**RE: Coronado Village – Water Tank
Grading and Drainage Plan
Stamp Date: 11/16/17
Hydrology File: C18D017**

Based upon the information provided in your submittal received 11/16/2017, the Grading and Drainage Plan **is not** approved for Building Permit. The following comments need to be addressed for approval of the above referenced project:

ENGINEER'S SEAL 	CORONADO VILLAGE ALBUQUERQUE, NM		DRAWN BY JJG
	NEW STORAGE TANK PLAN		DATE 11/15/2017
	TERRA WEST, LLC 5571 MIDWAY PARK PLACE NE ALBUQUERQUE, NM 87109 (505) 858-3100 www.tierwestllc.com		2014034 UTILITY PLAN-NMED
	SHEET # C1		JOB # 2014034

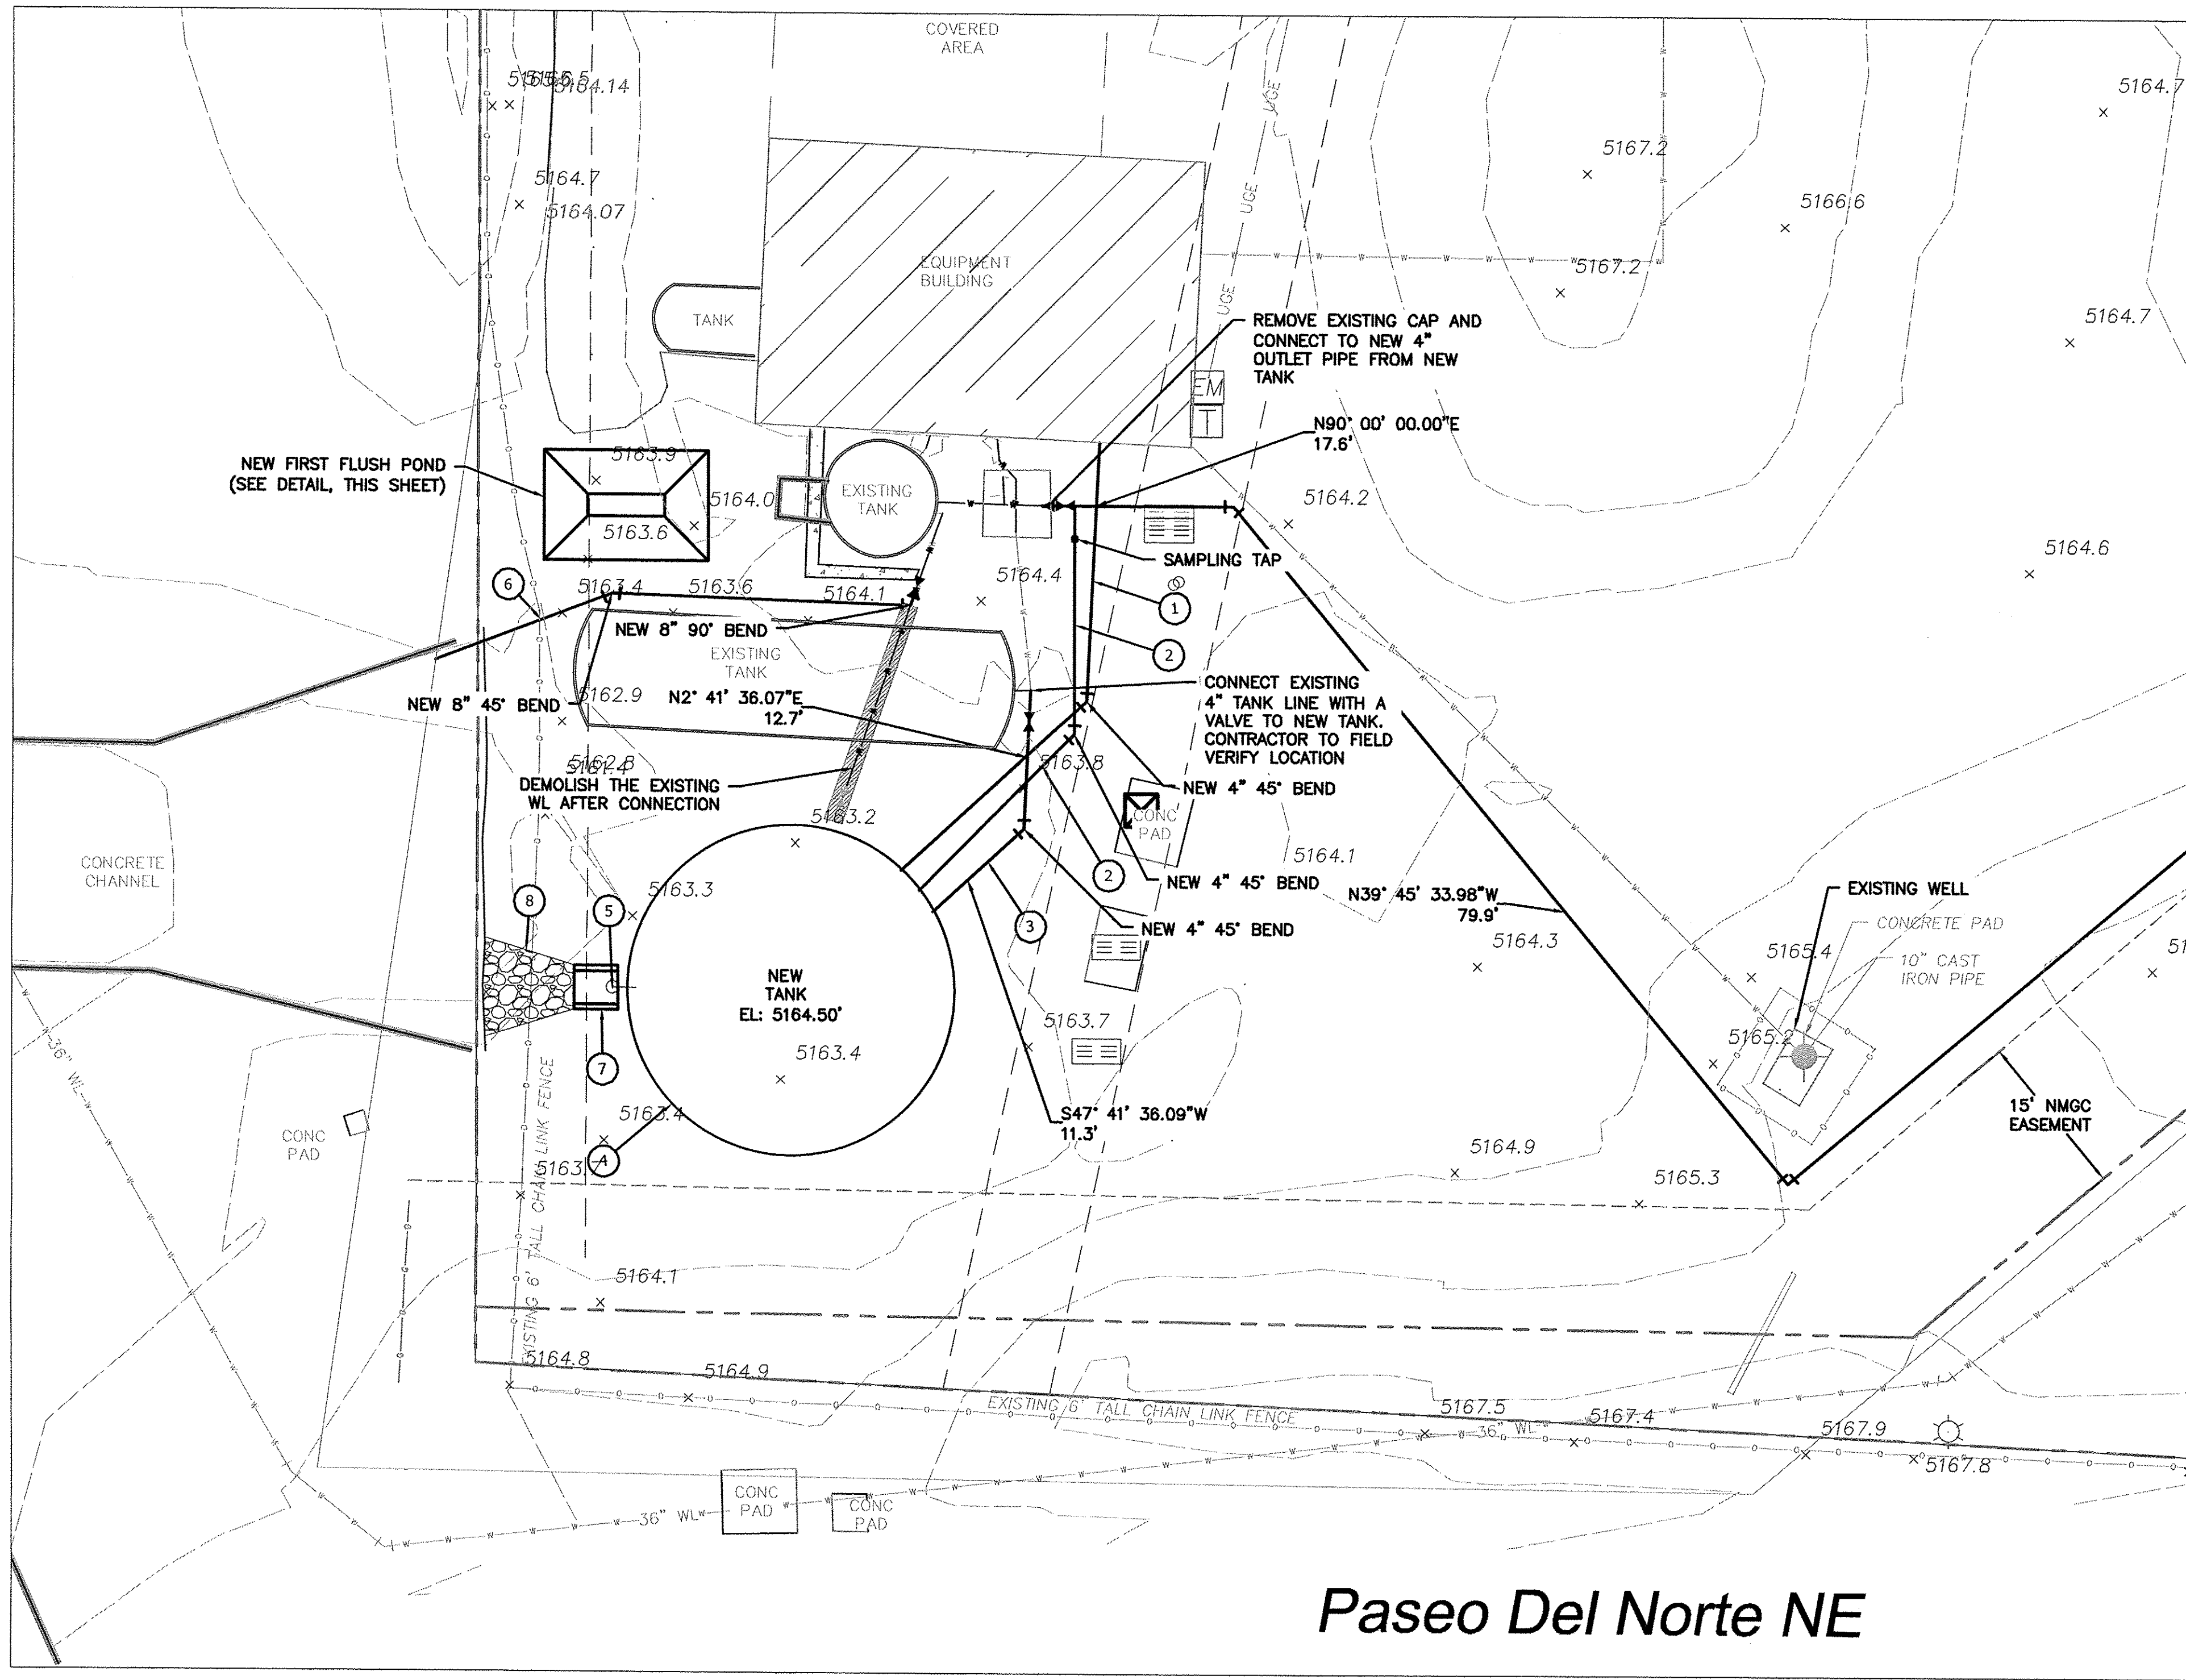
1. Please show and label the flood plain “AO” on the Grading Plan.
2. Please provide the benchmark information for the survey contour information provided.
3. Please relocate the first flush pond. It needs to be directly downslope of the proposed tank so that the runoff goes into it prior to running down the concrete channel rundown to the North Diversion Channel.
4. Please either relocate the proposed new tank out of the “AO” flood plain or raise the pad elevation one foot above the 100 year elevation for this “AO” flood plain. This 100 year elevation may have to be calculated.
5. If the location of the proposed new tank is to remain, then please create a diversion swale around the tank to allow the existing runoff flow the concrete channel rundown to the North Diversion Channel and not have the proposed new tank be a blockage for the existing drainage flow.
